GOVERNMENT OF THE DISTRICT OF COLUMBIA
DEPARTMENT OF TRANSPORTATION

MEMORANDUM

SUBJECT: **BZA Case No. 18972** – 3605-3615 Minnesota Avenue SE

Figure 1. Proposed Site Plan (Source: Applicant)

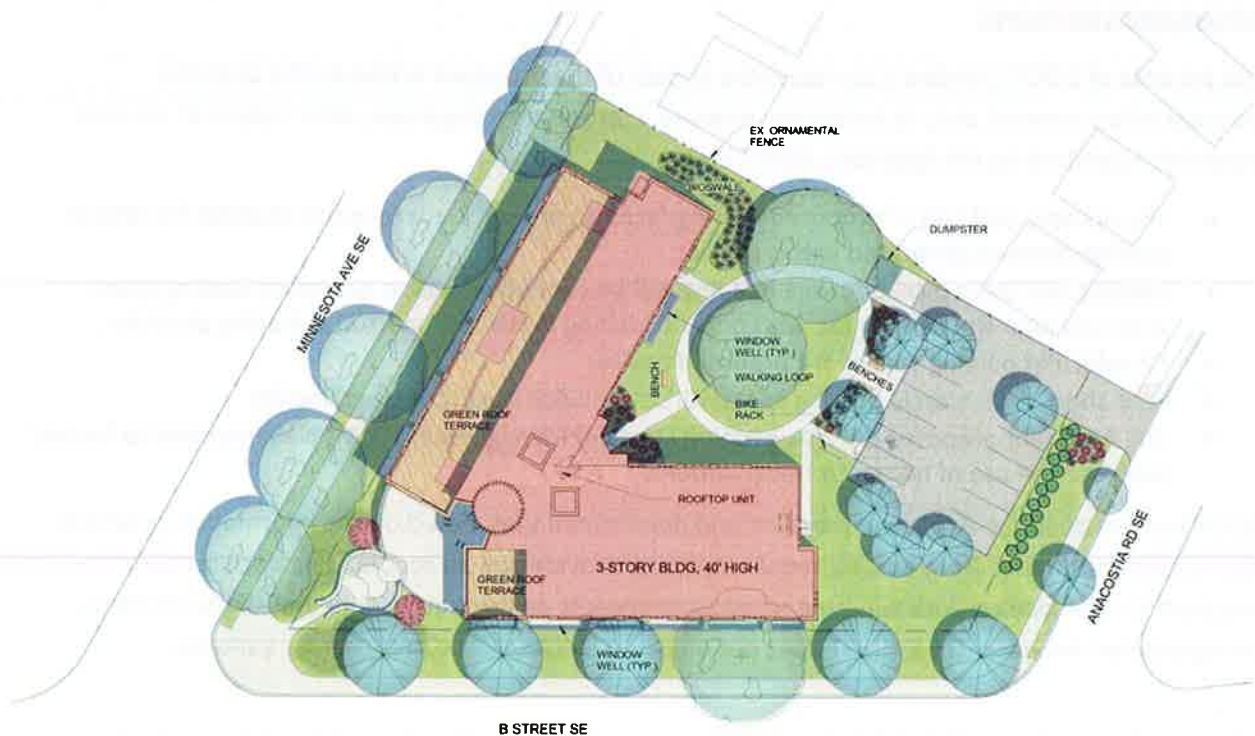
The proposed building is providing 12 vehicular parking spaces, two of which are handicapped spaces, the provision of which meets zoning regulation to provide one for every six residential units. These spaces will be provided in a surface parking lot accessed via a curb cut and driveway from Anacostia Road.

Per District code, this apartment building requires a minimum of one 55' loading berth, one 200 sf loading platform, and one 20' delivery space. The project as proposed provides one 30' loading berth, one flush 100 sf loading platform, and no additional delivery space. As part of this zoning action, a workable loading concept was provided to support the action sought and to show this building can be later permitted as part of the public space permitting process. Access to the loading provided is via the same curb cut and driveway serving the parking lot. The Applicant provided truck turning diagrams showing that the proposed loading layout accommodates front-in/front-out movements, in keeping with DDOT's Design and Engineering Manual (31.2.3.2).

A 30-foot loading berth is sufficient to accommodate move-in/move-out truck activities associated with the proposed residential unit size mix. In the rare event that larger trucks must service the site, Emergency No Parking signs are available from DDOT to reserve a loading area along the curbside. Additionally, the requested loading relief is consistent with other loading-related relief requests throughout the District.

DDOT finds that the number and size of proposed loading facilities are sufficient to accommodate the typical loading demand generated by the number and unit composition of dwelling units included in this project. DDOT expects the Applicant to comply with DDOT's standards for loading, the details of which will be addressed further, as necessary, as part of the permitting process for this property.
